**GEORGETOWN MIDDLE-HIGH SCHOOL RENOVATIONS
Georgetown, MA**

ADDENDUM NO.2

February 13, 2015

RE2-03
 Ref. Dwg. E1-4-4BC

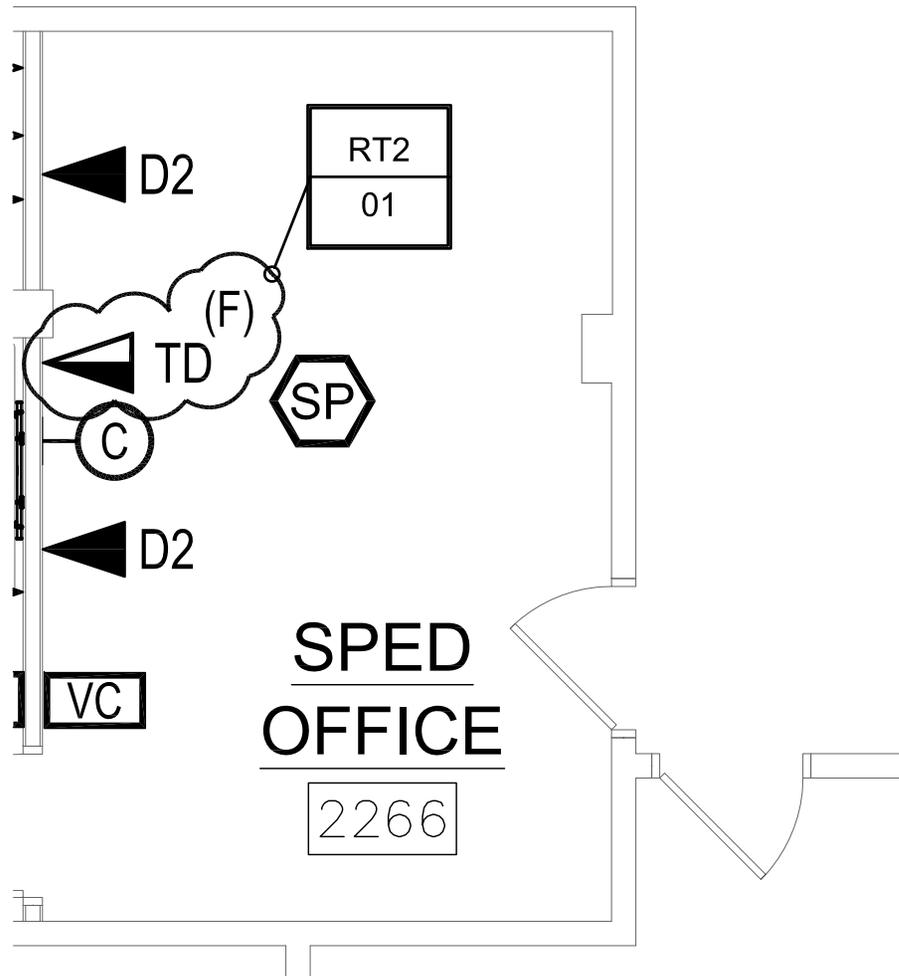
ADD 2-60 E1-4-4BC – ELECTRICAL ROOF PLAN AREAS B AND C
ADDED heat trace at Alternate Gym Room 2291 and Gymnasium Room 2293. ADDED heat trace note. Refer to attached sketches RE2-02 and RE2-03.

- 3 INTERCEPT, EXTEND AND RECONNECT EXISTING 120V BRANCH CIRCUIT SERVING CONVENIENCE OUTLETS IN ALTERNATE GYM RM 2291 TO HEAT TRACE SYSTEM. PROVIDE ALL REQUIRED INTERCONNECTIONS FOR CONTROLS AND POWER FOR A COMPLETE SYSTEM.
- 4 INTERCEPT, EXTEND AND RECONNECT EXISTING 120V BRANCH CIRCUIT SERVING CONVENIENCE OUTLETS IN GYMNASIUM RM 2293 TO HEAT TRACE SYSTEM. PROVIDE ALL REQUIRED INTERCONNECTIONS FOR CONTROLS AND POWER FOR A COMPLETE SYSTEM.
